SERVICE BULLETIN**Part No.: LSxxx**

Description: Loud Speaker 300/600W External	
Service Manual: ASM-LS	Service Bulletin No.: ASM-LS-603-0001
ECO No.: ECO# 1130	Subject: Re-entrant tip securing (MOD 2)

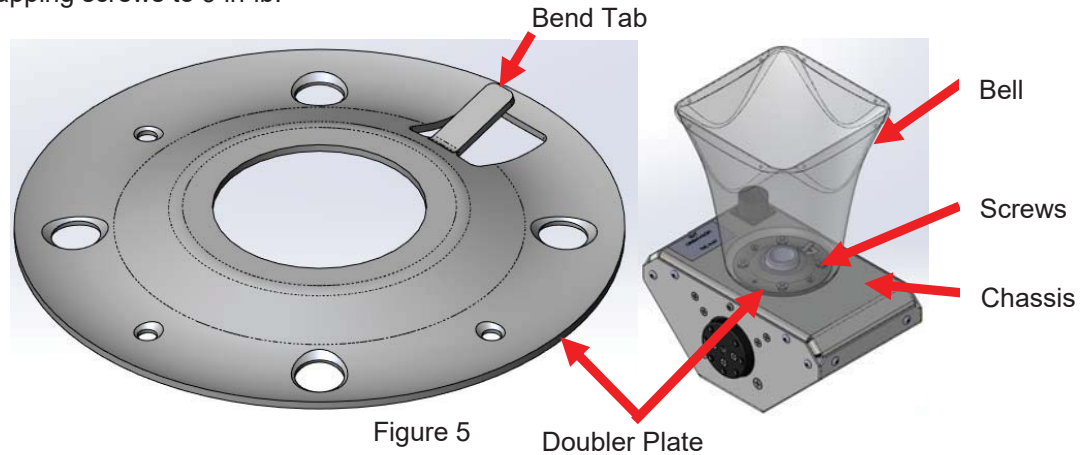
- 2.1.2.1 Position bell as shown below, place the new doubler plate with locking tab into the bell. Align doubler plate holes with holes in bell/chassis, the larger holes in the doubler plate align with the larger holes in the bell/chassis. Apply Loctite 271 to the four 1/4" screws. **Do not** Loctite the two #10 self tapping screws. With a #2 Phillips screwdriver, fasten the 6 screws used to retain the doubler plate. Torque 1/4" screws to 30 in-lb. Torque #10 self tapping screws to 9 in-lb.

Figure 14

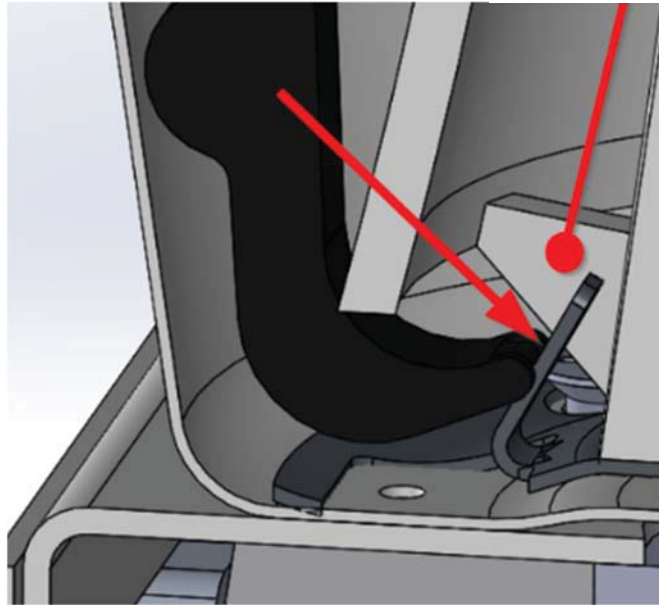
AEM does not have a history of re-entrant tips loosening that previously would've caused a mechanical design change. However, AEM is committed to the safety of its customers and therefore has made a design improvement to its speaker series. This modification consists of replacing the doubler plate with one that includes a mechanically formed positive locking tab which engages a structural portion of the re-entrant tip during assembly. The mechanically formed locking tab limits the re-entrant tip from counter-clockwise rotation to prevent the possibility of rotating loose.

- 2.1.3.6 Inspect that the tab has bent into the removal path of the re-entrant tip cross member as shown.

Figure 15

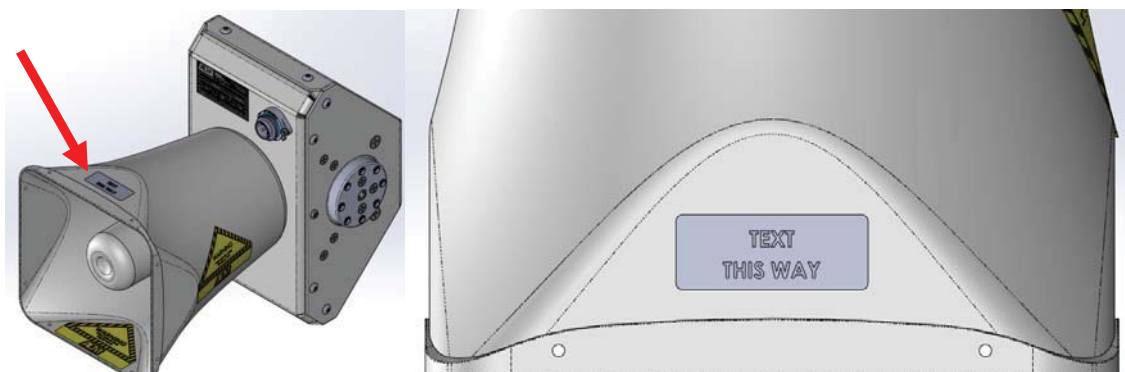
Apply re-entrant tip warning label to each bell as shown below.
